SUBJECT: Savannah River Site's Responses to the Regulatory Comments on the Effectiveness Monitoring Report (EMR) for the C-Area Groundwater (CAGW) Operable Unit (OU) Removal Action (U) - July 2023 through June 2024 (SRNS-RP-2024-01334, Revision 0, November 2024) SEMS Number: 82

SRS Response to the U.S. Environmental Protection Agency's Comments on the Effectiveness Monitoring Report (EMR) for the C-Area Groundwater (CAGW) Operable Unit (OU) Removal Action (U) - July 2023 through June 2024 (SRNS-RP-2024-01334, Revision 0, November 2024) SEMS Number: 82

Figure CR-5. CRW026C Microbial Activity November 2023

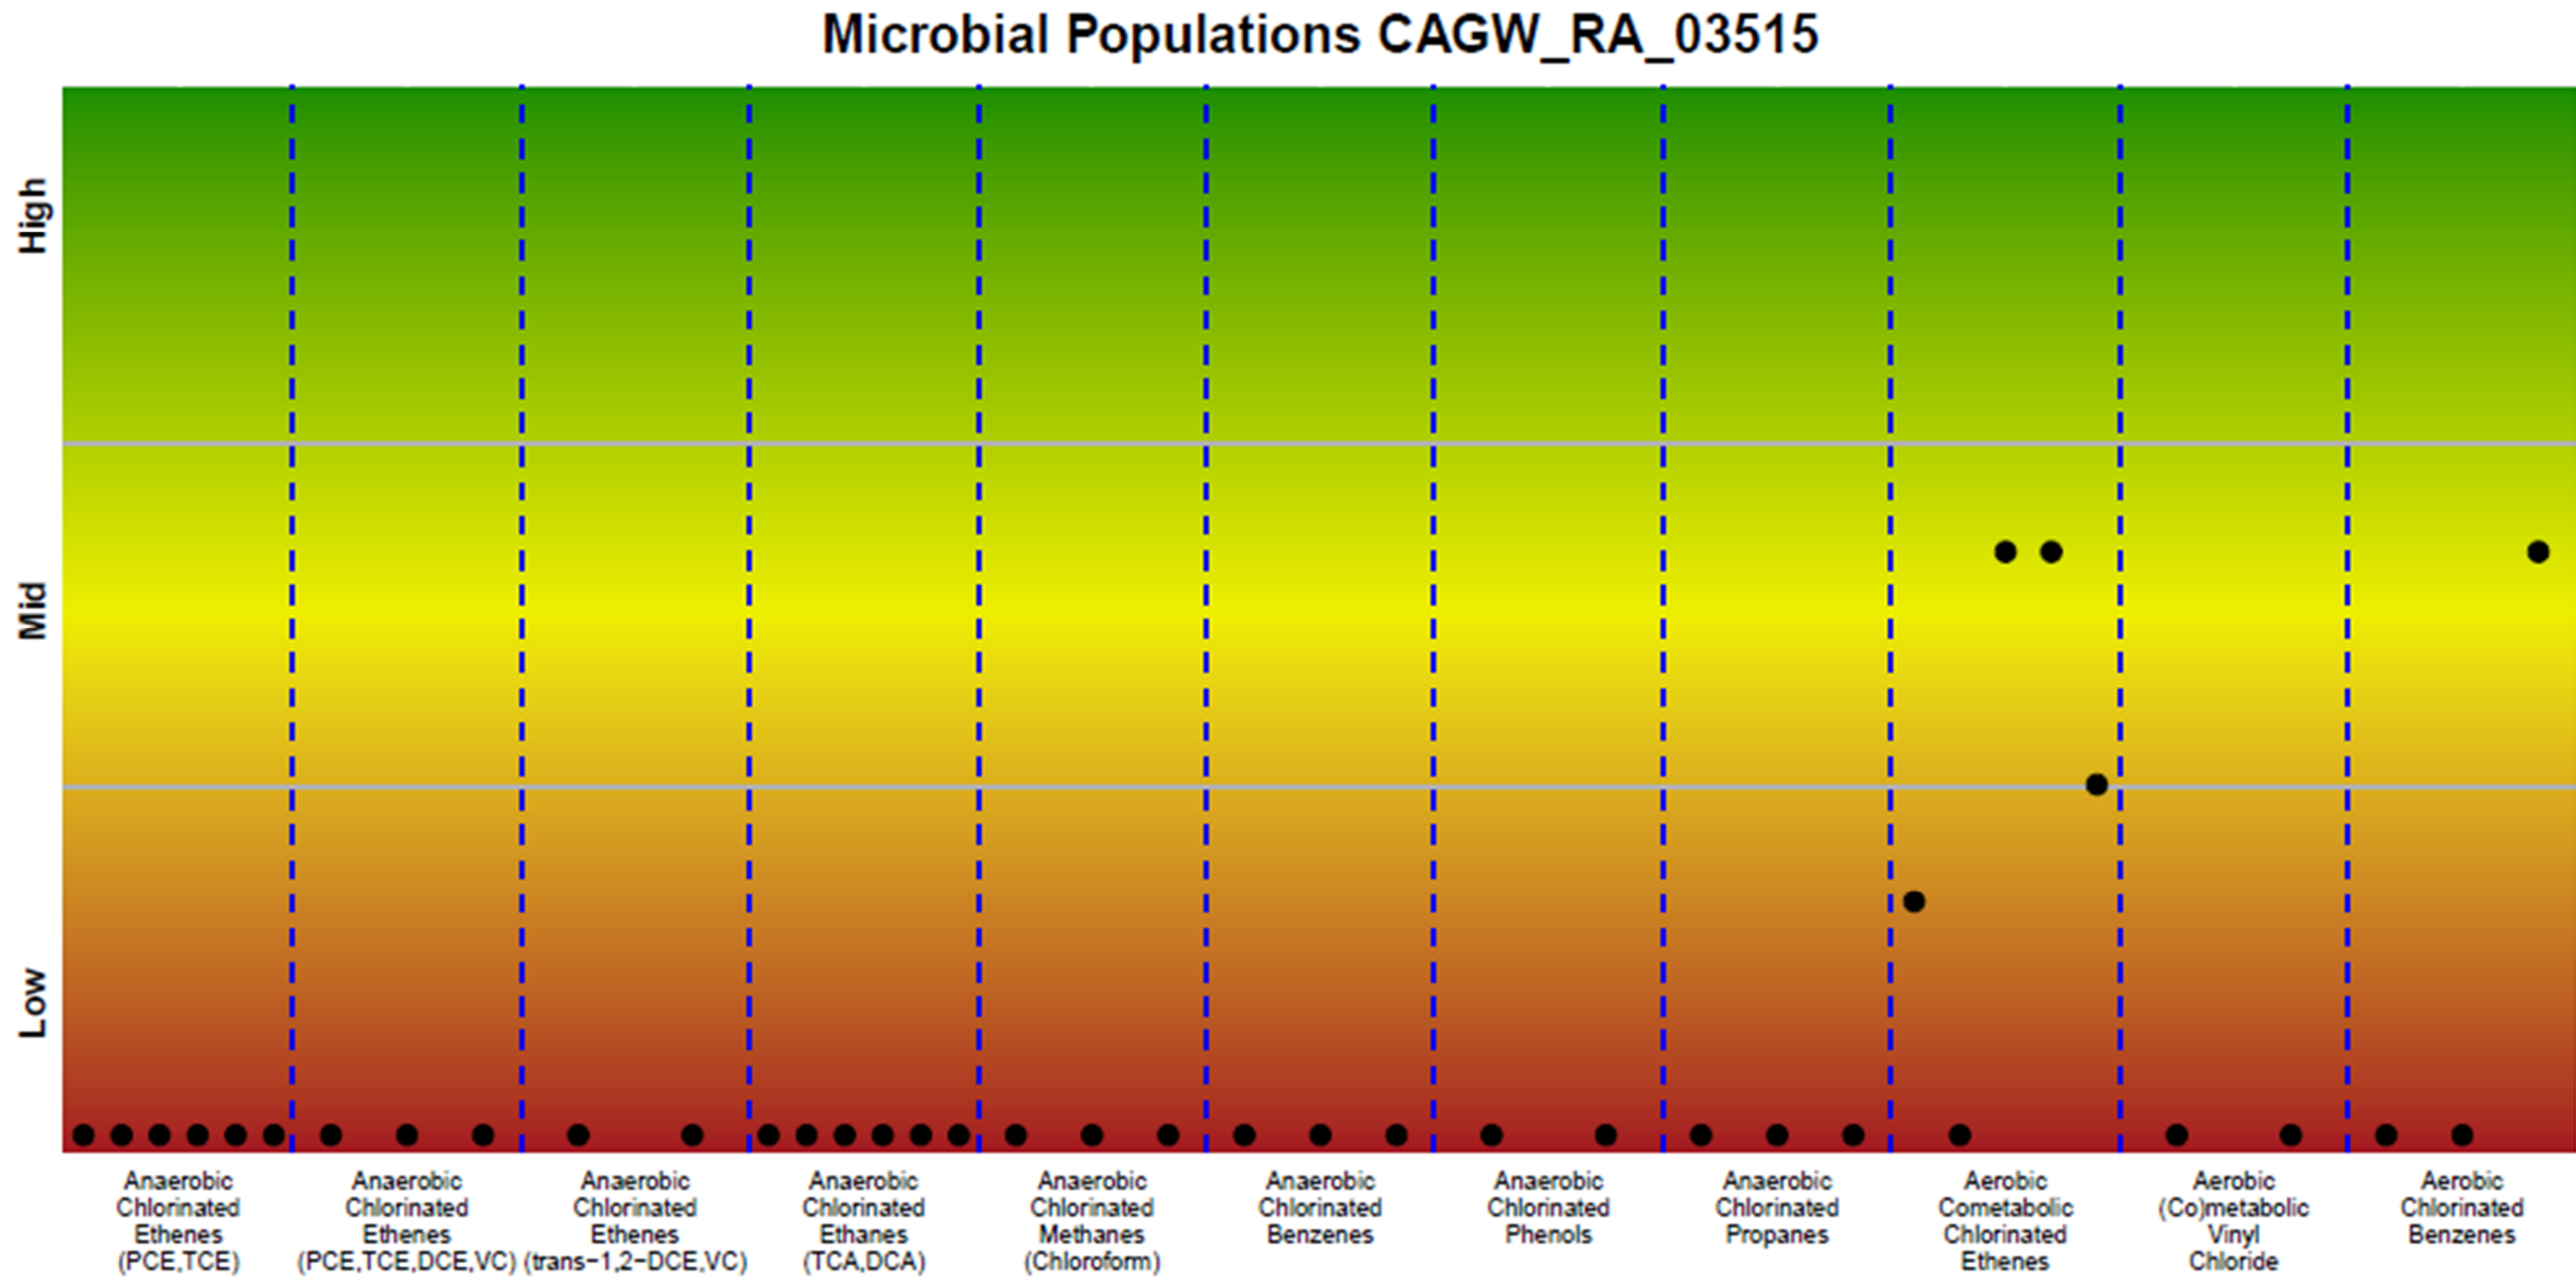
6. **Section 3.4.1.9, BioTrap QuantArray-Chlor® Microbial Data, Page 22 of 118:** The text references microbial count charts in well CRW026C from November 2019 to June 2023 (i.e., Figures 23-34), but it is unclear why microbial count charts were not produced for the results collected during the current reporting period. Table 5 (BioTrap QuantArray® Data [4Q23 & 2Q24]) reports the microbial results collected in November 2023 and May 2024. *Please revise the EMR to include microbial count charts for the November 2023 and May 2024 results in well CRW026C.*

Response: Agree.

Two additional figures (attached as Figure CR-5 and Figure CR-6) for 4Q23 and 2Q24 BioTrap data should have been included in the 2024 CAGW OU groundwater report. Future reports will ensure that microbial count charts for the current reporting period are included.

Figure CR-7 (Revised Figure D-1). November 2023 TCE Concentrations in the Upper Aquifer Zone – Middle Aquifer Zone (UAZ-MAZ) of the Upper Three Runs Aquifer

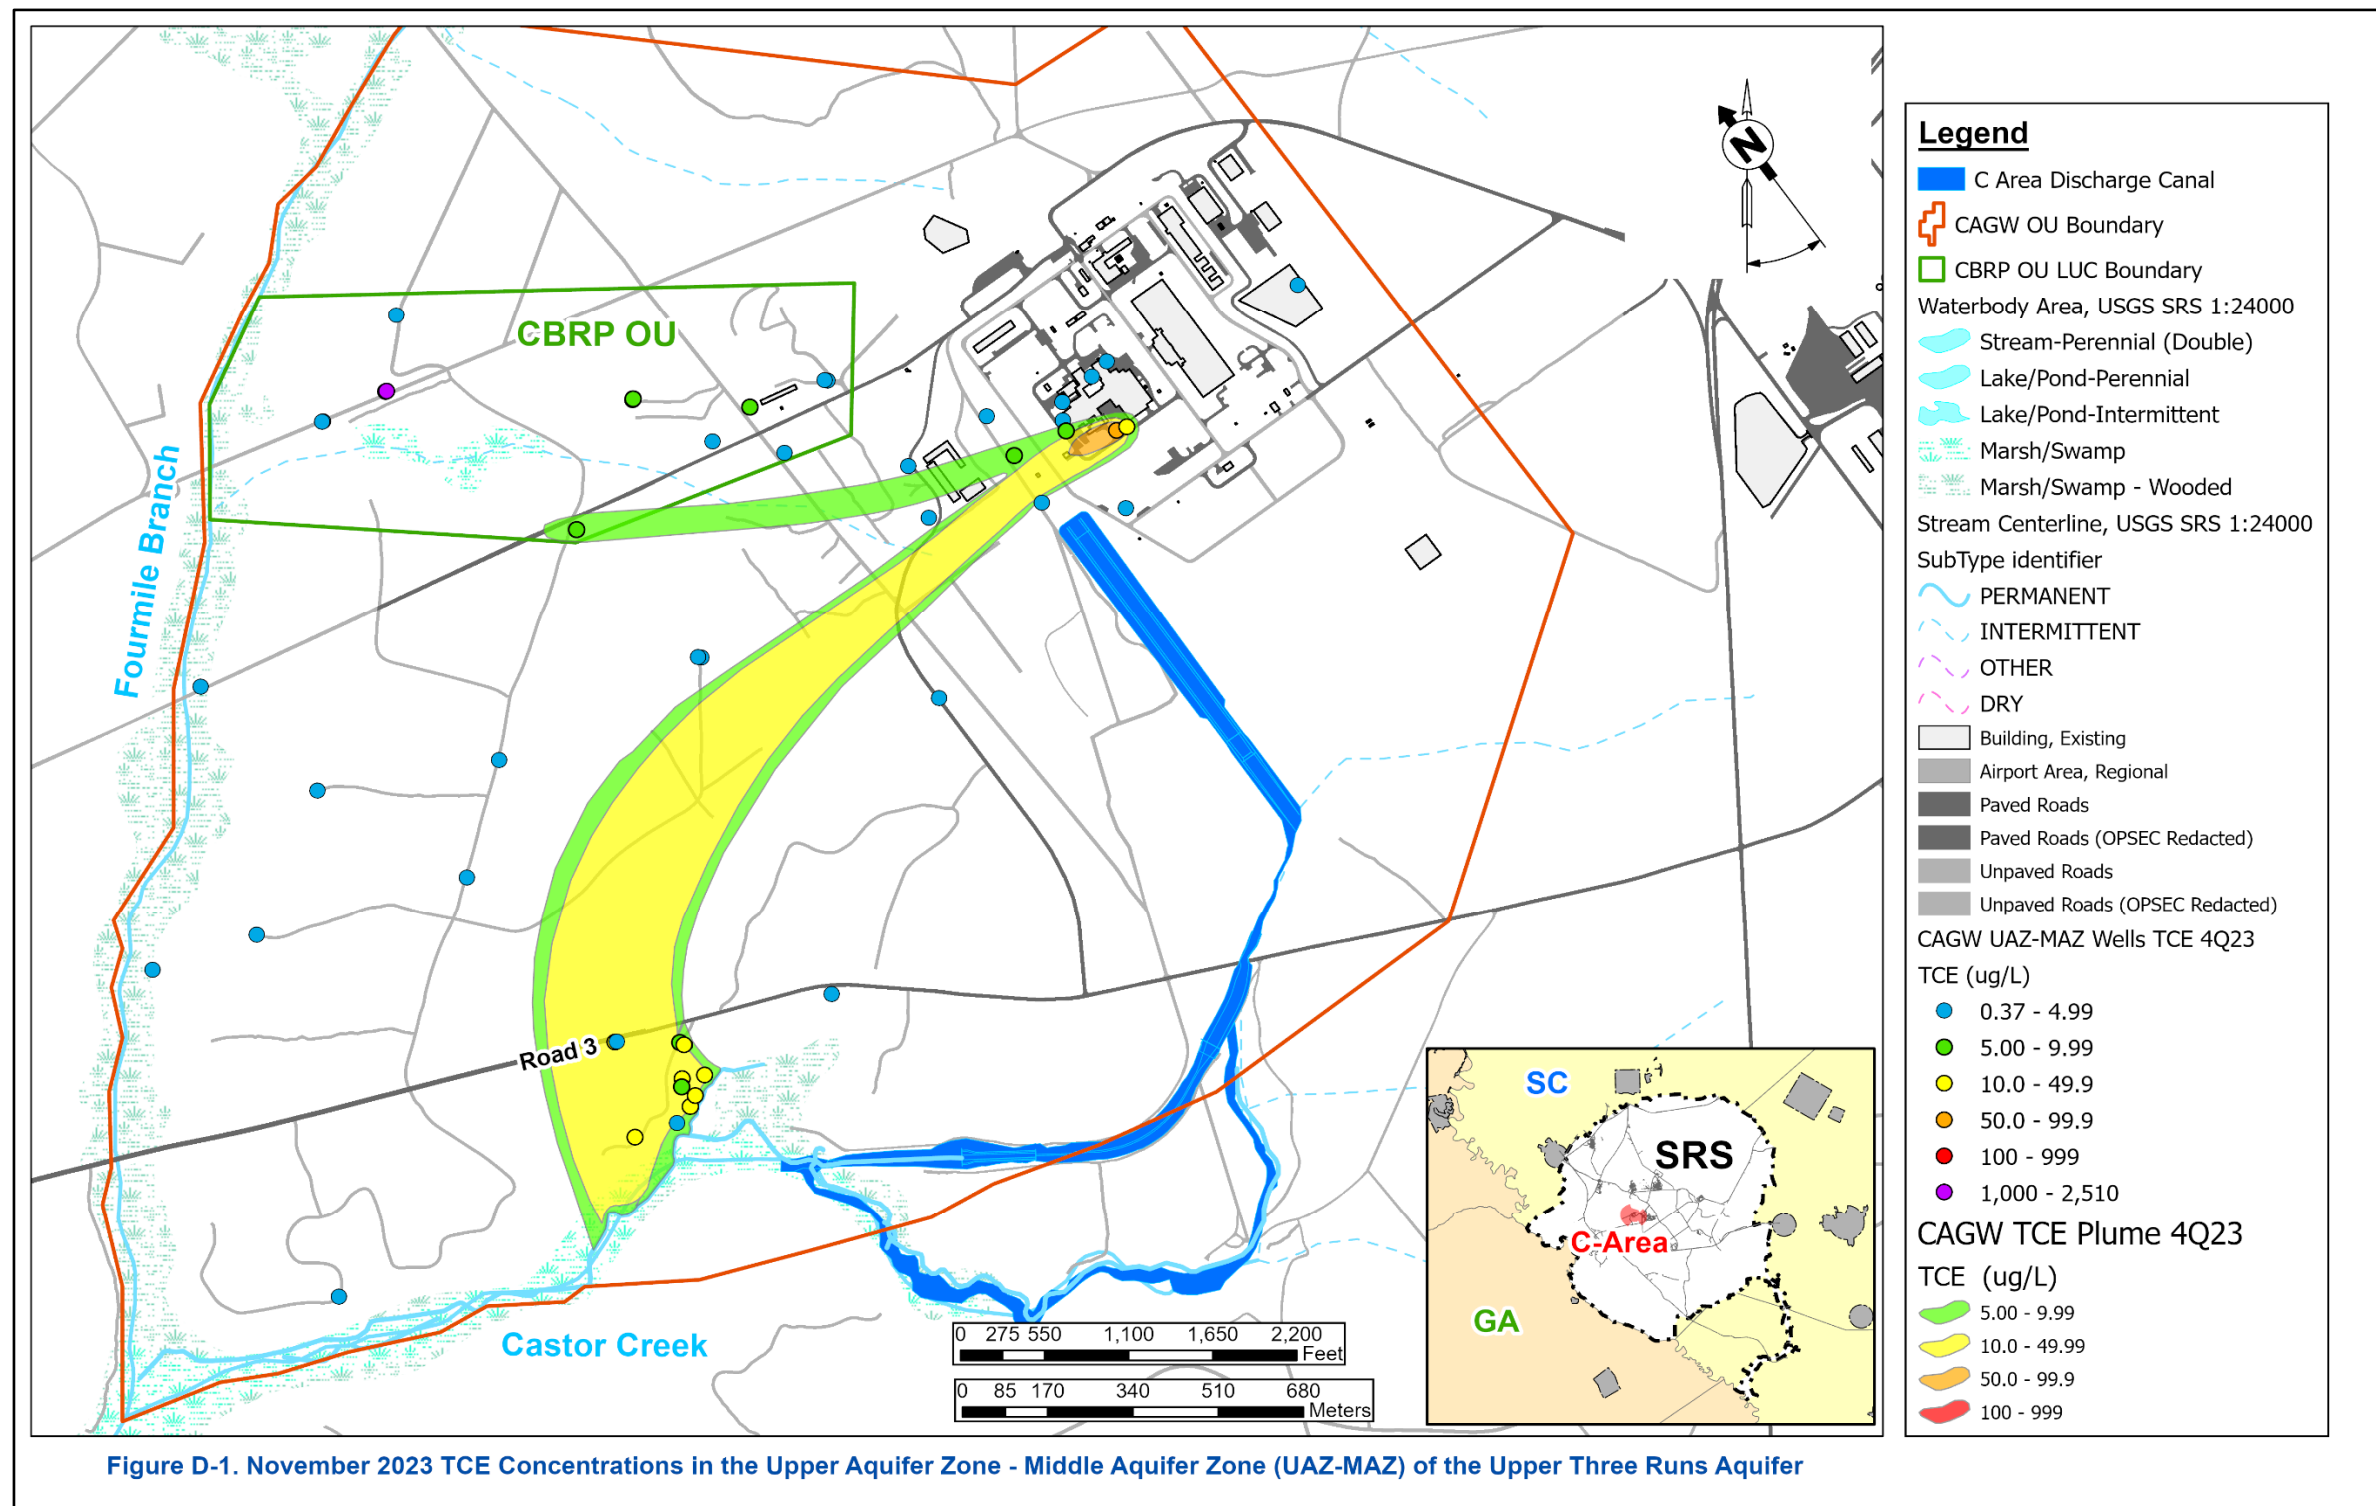
- 10. Appendix D, Figure D-1, November 2023 TCE Concentrations in the Upper Aquifer Zone - Middle Aquifer Zone (UAZ-MAZ) of the Upper Three Runs Aquifer, PDF Page 313:** It is unclear why the TCE plume is not shown to extend toward the west on this figure. Three wells are shown to have concentrations above 5 ug/L (i.e., the green dots) that are not included in the plume. Based on comparison with Figure 2 (CAGW OU TCE Plume 4Q2023), it appears these wells include CSB017D, an Upper Aquifer Zone well; however, without labels on the wells, it is difficult to identify the other two wells. Further, it appears that well CRW010CU is not included on this figure, and TCE was detected at 10.1 ug/L in November 2023. *Please revise Appendix D to include the wells with TCE concentrations greater than 5 ug/L in the plume. Also, please label the wells and include well CRW010CU on the figure of the UAZ-MAZ TCE plume.*

Response: Agree.

Figure D-1 should have included UAZ station CSB017D and MAZ station CRW010CU, which are just outside of the C-Area fence line and south of Twin Lakes, respectively. Please see attached Figure CR-7 (revised Figure D-1) which shows UAZ station CSB017D and MAZ station CRW010CU and well labels.
